PRE2025/893
189-195 Teviot Road, Greenbank

MEETING NOTES

Priority Development Area	Greater Flagstone PDA
Property Address	189-195 Teviot Road, Greenbank
Lot on Plan Description	Lot 17 RP210430
Proposal	Material Change of Use for 67 Multiple Dwellings; and Reconfiguring a Lot for 21 Residential Lots and 1 balance lot.

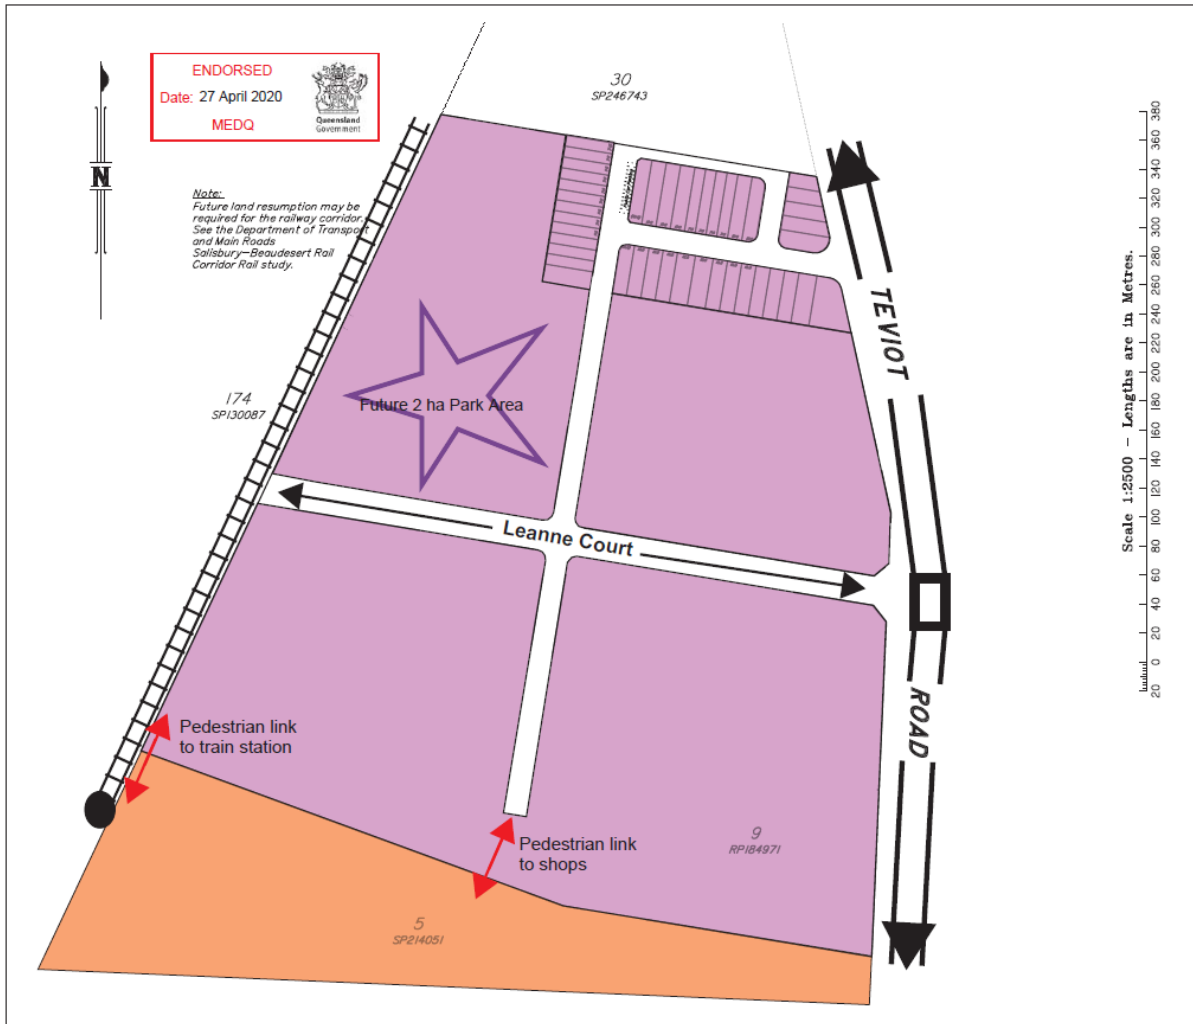
20. The southwest corner of the site is subject to flooding, as shown in the extract above. Any earthworks in the flooded area should be appropriately compensated. Also, the floor level or stormwater management devices within the floodplain must satisfy the Council's flood immunity requirements. Submit a floodplain management report prepared by a Registered Professional Engineer Queensland (RPEQ), specialised in flood hydraulics.
